# 5.0 Planning and Consultation

## 5.1 Pre-Planning Application Advice

**Proposal at 20 Red Lion Street, London WC1R 4PQ**

### 1. Plantroom enclosure (Street view)

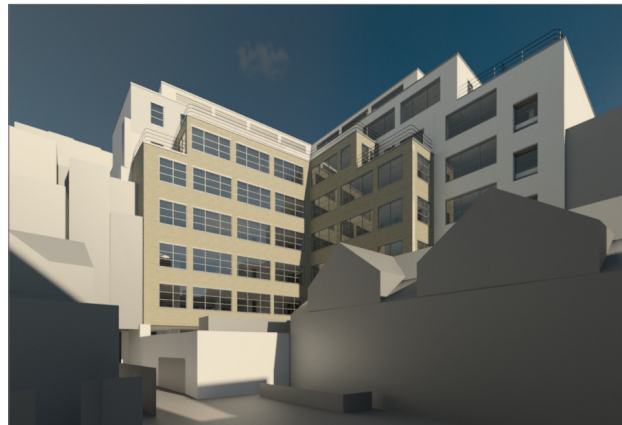
- 1 Explore further how the plantroom enclosure can be integrated into the design of the roof top extension through:
  - reducing its height
  - pulling it back from the main street frontage
  - increasing the parapet of the 6th floor to disguise its mass

Following a series of 3D studies we have concluded that a combination of reducing the plantroom enclosure by 500mm and increasing the parapet by 500mm mitigates any view of the plantroom above the extension from the street and Three Cups Yard.

Plant screen 2000mm high, plant position as current plans, 6th floor parapet raised 500mm

### 2. Gable to Sandland Street

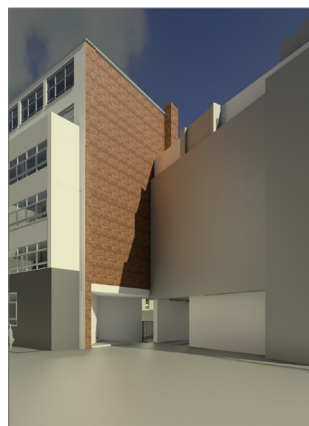
- 2 Consider a view of the gable to Sandland Street and the pub. It is likely that the rooftop extension will need to be stepped back to match the rest of the proposals

A view of this interface is now included and we confirm that the rooftop extension has been stepped back from the gable.

Post consultation - wall set back
